ALTERATION OF TERRAIN

AMENDMENT REQUEST

AMOSKEAG BEVERAGES

GE Project No. 26-0218-5

OS#1/OUTLET STRUCTURE DETAIL FOR WET POND#1

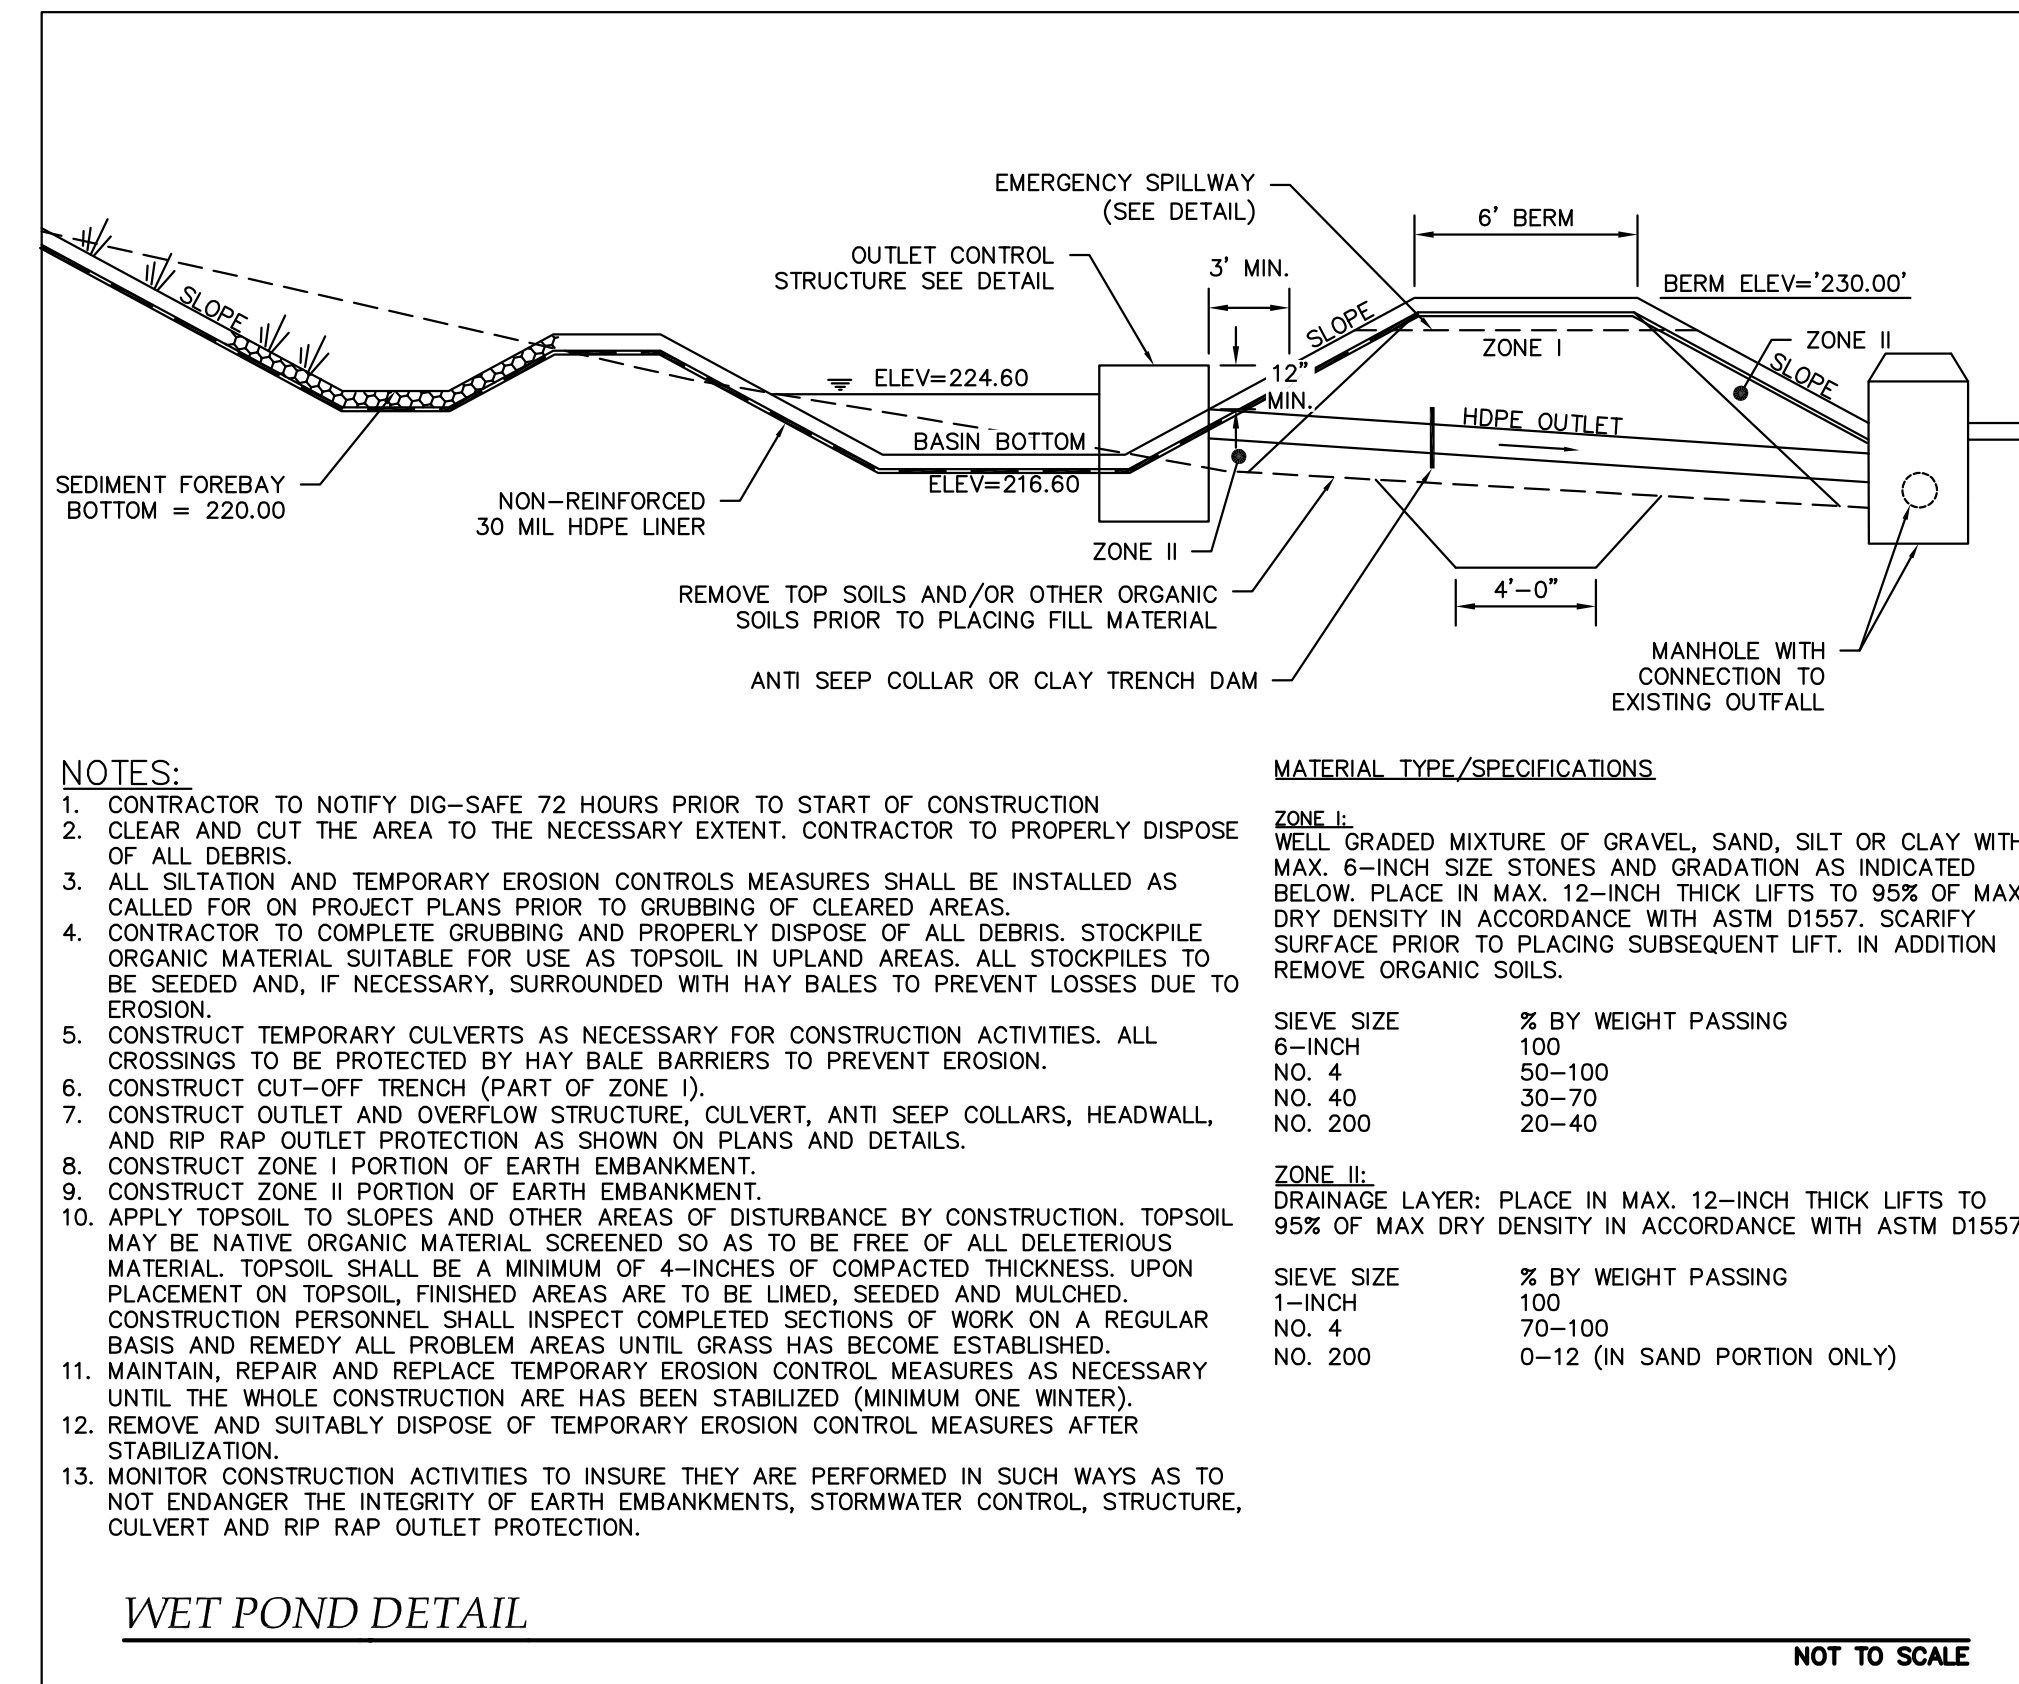
RISER MODIFIED. "AMOSKEAG BEVERAGES COVERED STORAGE ADDITION" PLAN SET FOR UPDATED DESIGN

TITLE:
POST-DRAINAGE AREA PLAN

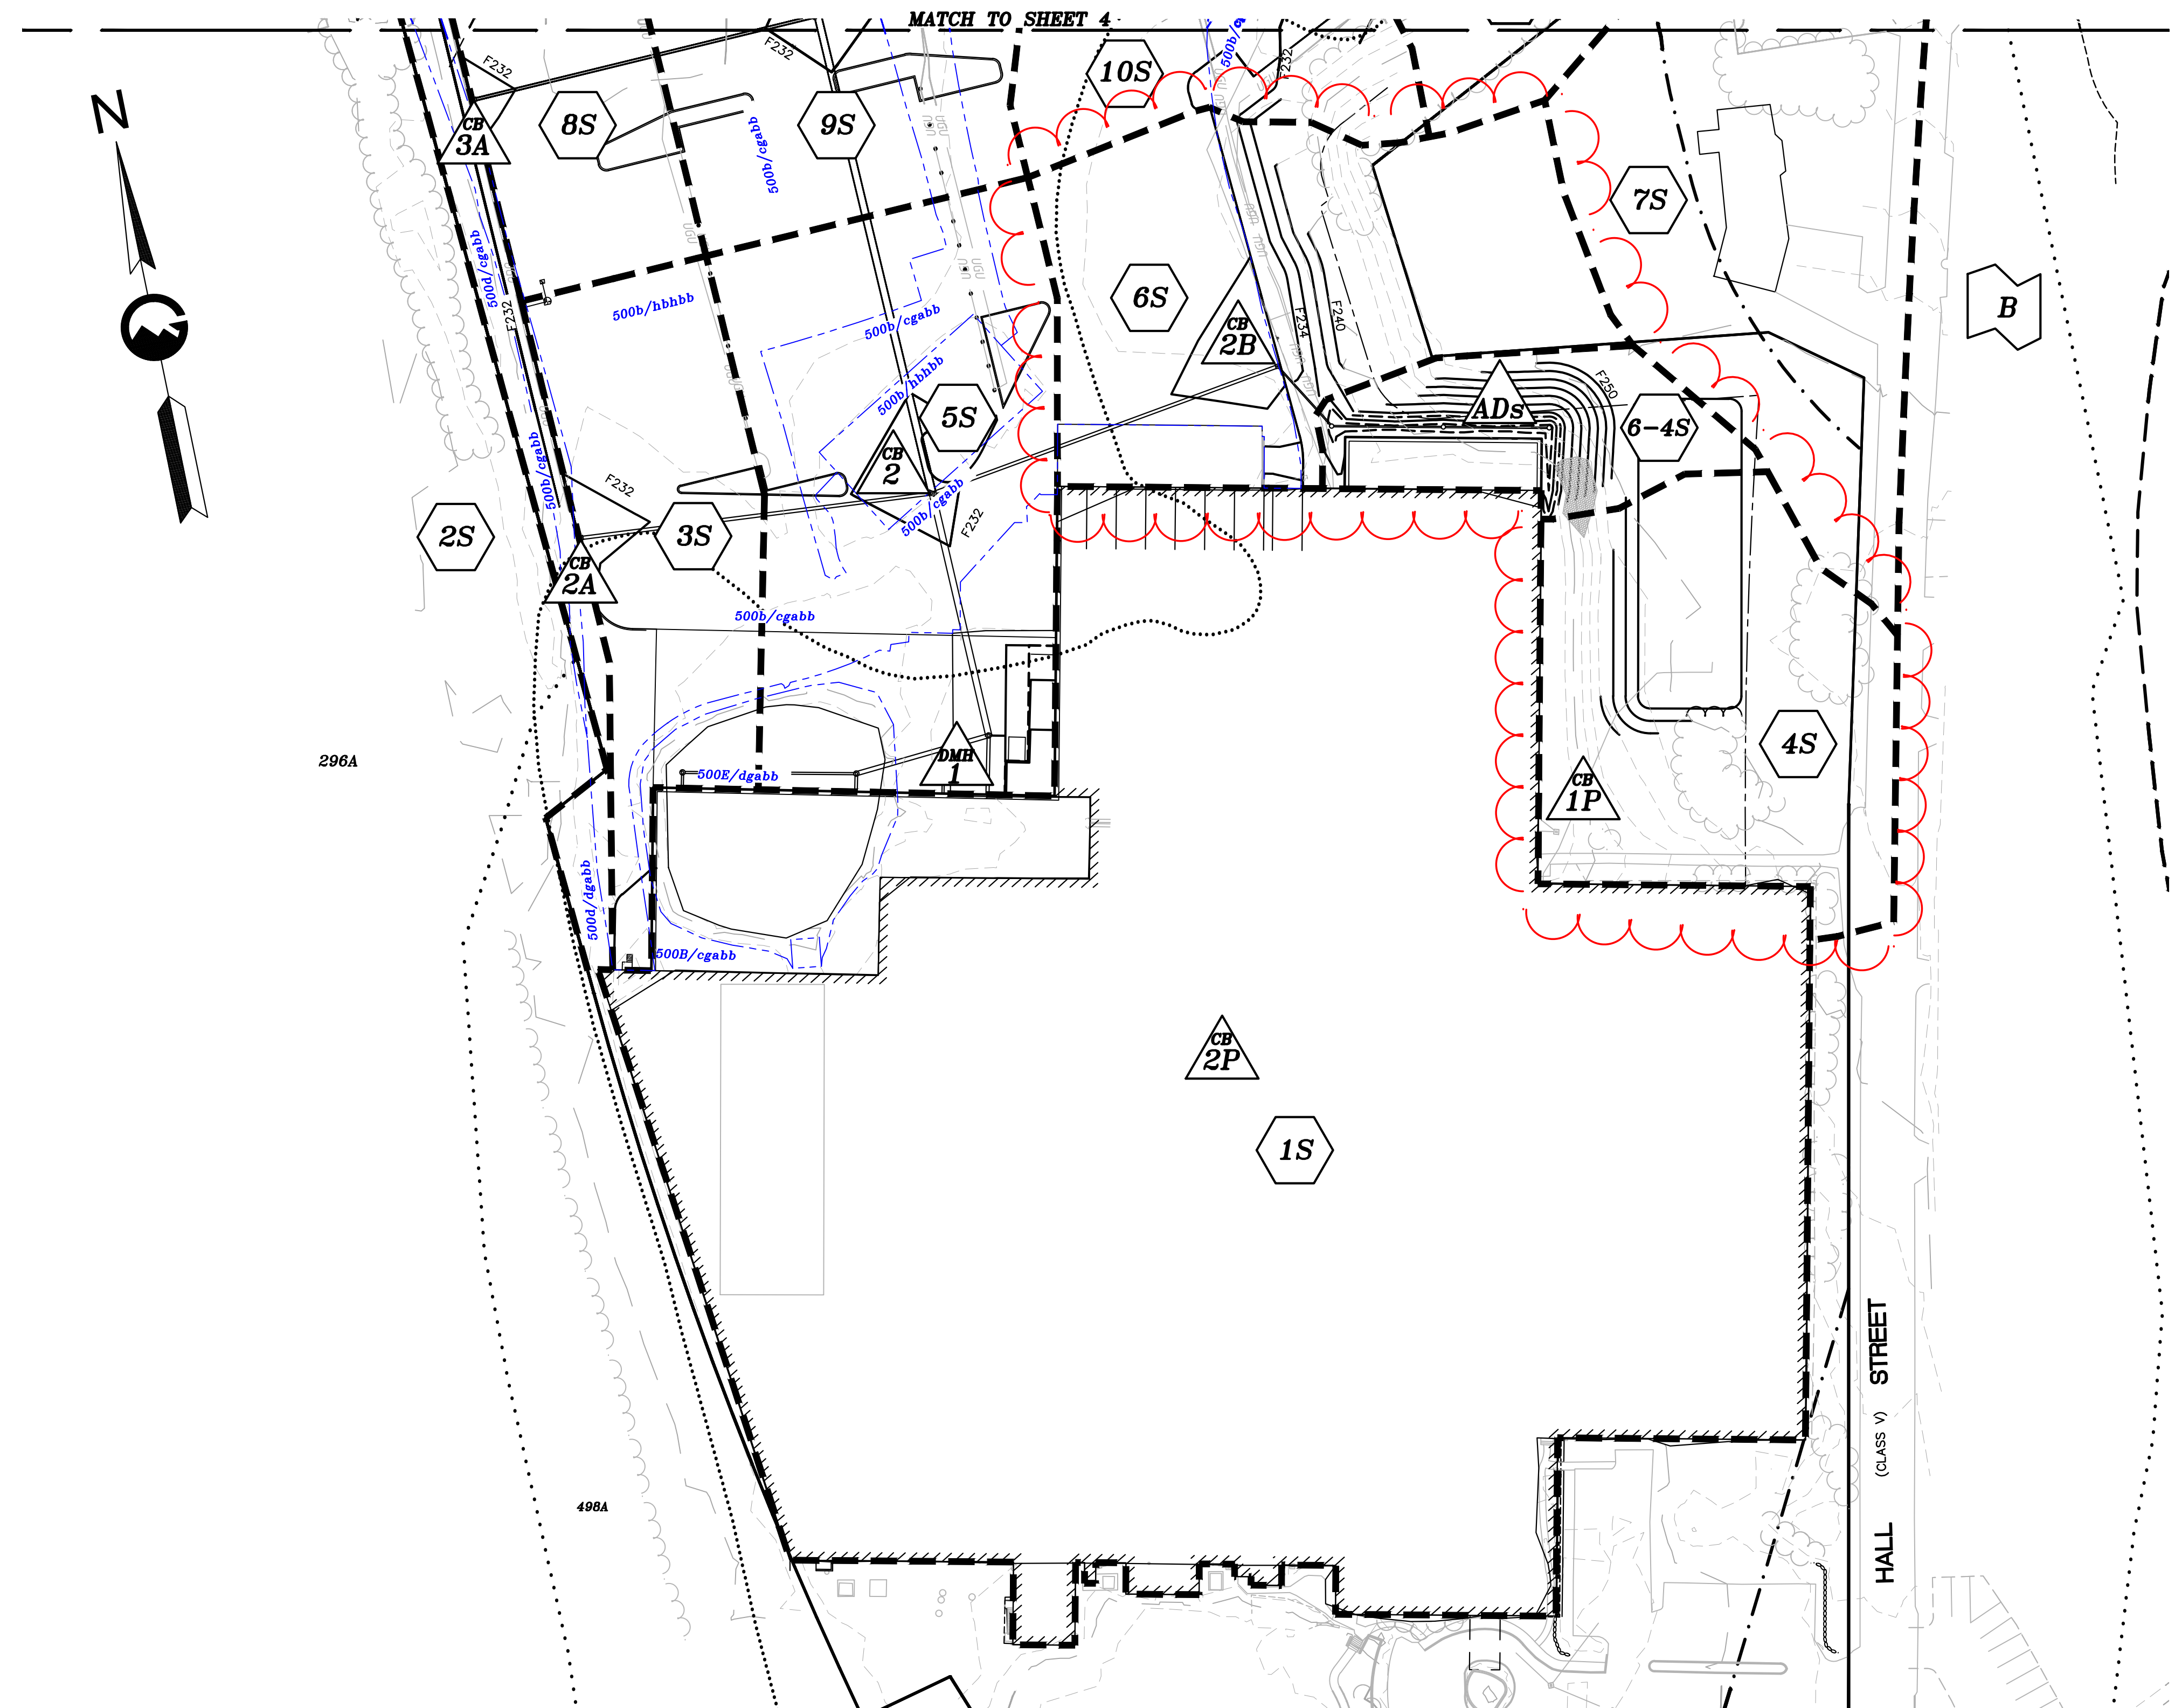
NO.	DATE	REVISIONS
1	04/17/26	ADDED NEW COVERED STORAGE & ADS
